# UNITED STATES PATENT AND TRADEMARK OFFICE

10/527,856

Edward E. Heald

<b>Office Action Summary</b>	<b>Application No.</b> 10/527,856	<b>Applicant(s)</b> HEALD ET AL.	
	<b>Examiner</b> GALEN HAUTH	<b>Art Unit</b> 4111

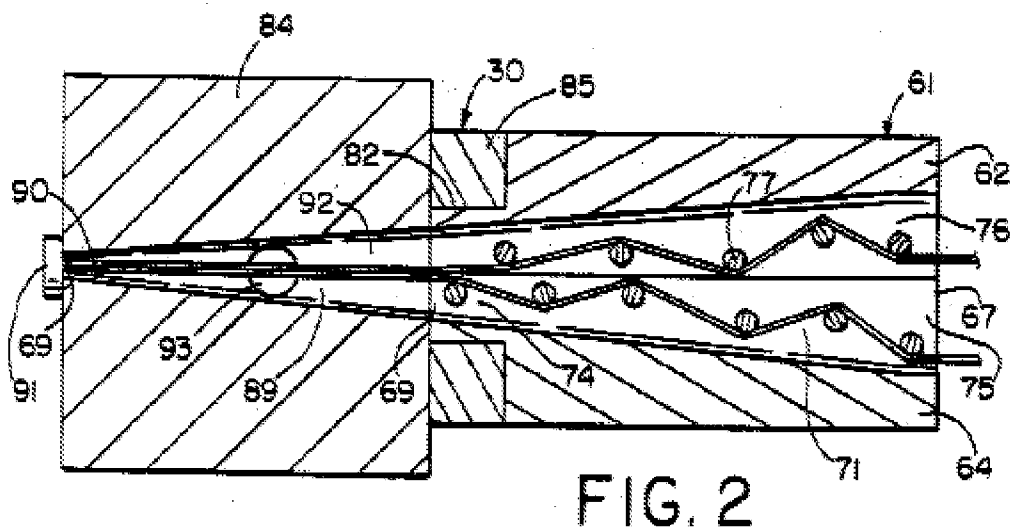
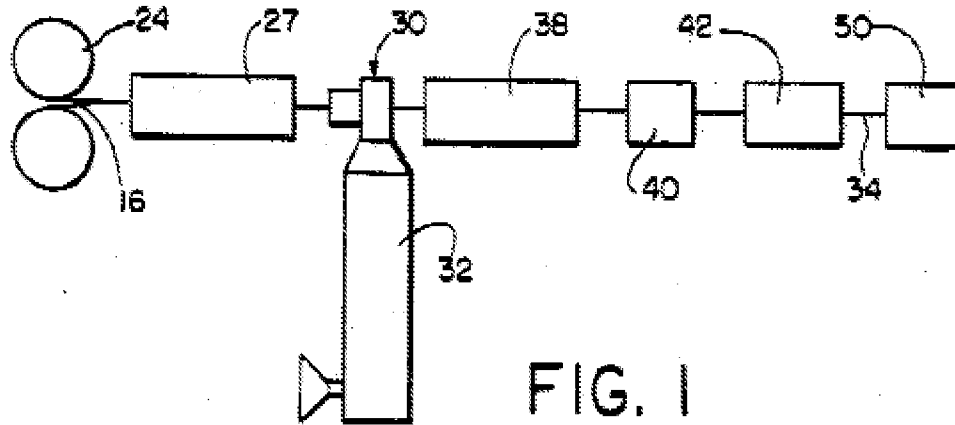
5. Claim 6 is rejected under 35 U.S.C. 102(b) as being anticipated by Azari (PN 5268050).

a. Azari teaches a pultrusion device comprising taking fibers from spools, preheating the fibers in an oven, feeding the fibers into a die, delivering a thermoplastic melt to the fibers impregnating the fibers, forming a consolidated fiber product, and cooling the product (col 5 ln 37-44). The claim language of a modular pultrusion die is interpreted to not require positively to have all claimed sections to be housed in a single molding die, hence does not preclude a series of communicating spaced sections. The pultrusion device taught by Azari is shown in the figures below. In Figure 1 is a preheat station (27); a die (30) which holds the infeed, reduction, and shaping section; and, a cooling section (38) in that order. In Figure 2 is a detailed view of the die (30) in which comprises a fiber infeed section (76) in which pins (77) are removable (col 6 ln 61-65) and replaceable (col 7 ln 1-4), a resin infeed and impregnation section (93), a

reduction section (90), and a shaping and consolidation section (91).

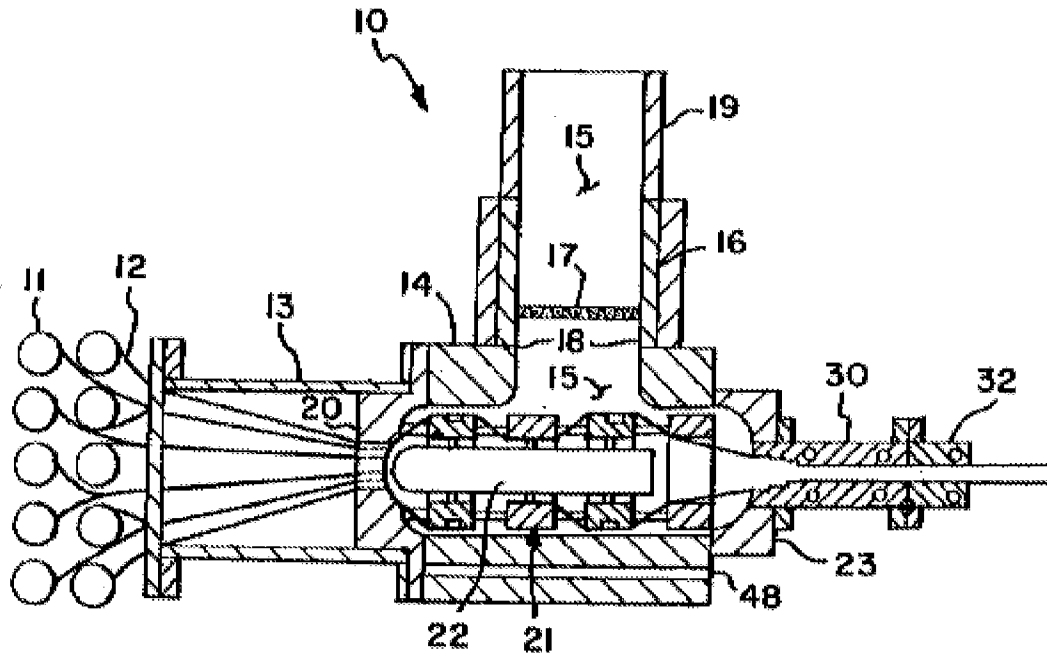
a. Wilson teaches a pultrusion apparatus in which fibers are pulled through a resin impregnation chamber, shaped and cooled. Referring to the figure below, Wilson teaches having a fiber preheating section (13), a fiber infeed section (20)

which is removable (col 4 ln 48-49) and therefor replaceable, a resin impregnating section (14), a reduction section (23), a consolidation and shaping section (30), and a cooling section (32).

a. With regards to claim 1, Wilson teaches pultrusion apparatus in which fibers are pulled through a resin impregnation chamber, shaped and cooled. Referring to the figure above by Wilson, Wilson teaches having a fiber preheating section (13), a fiber infeed section (20) which is removable (col 4 ln 48-49) and therefor replaceable, a resin impregnating section (14), a reduction section (23), a consolidation and shaping section (30), and a cooling section (32). Wilson

d. With regards to claim 5 with respect to claim 1, Wilson teaches that the fiber infeed section (20 in the figure above by Wilson) is removable (col 4 ln 48-49) and therefor replaceable.
